(v) The final argument for the proposed siting of the BAC Building is advanced by the long range planners: "the building contributes to the principle of the consolidation of the core of the campus." This illustrates the difficulty of translating a principle into development decisions.

The Immutability of the Long Range Plan

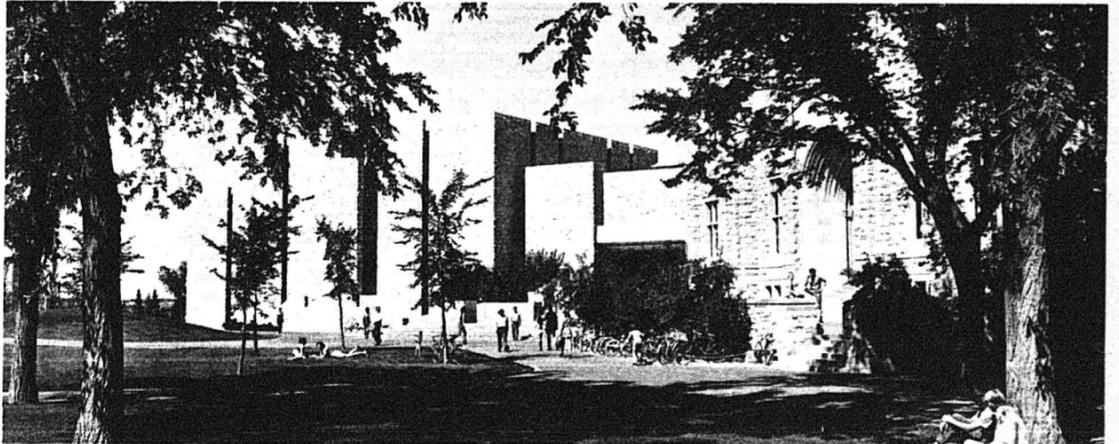
(iii) Any suggestion that the BAC Building should not be challenged because it is conforming to the plan can be countered very easily. The precise impact of the present proposal could not have been anticipated from the plan, because they differ in two important points of detail:

(a) the east-west walkway is routed through the BAC Building in the long range plan

(b) The BAC and Tory Buildings are separated by an elongated open space, not be a gallery and walkway. The reason is that HUB has been extended further north than was shown on the plan, and the food services building, which was to be at the east end of the BAC Building, was made during the detailed planning of HUB, so that its north end could be aligned with an east-west gallery between the BAC and Tory Buildings.
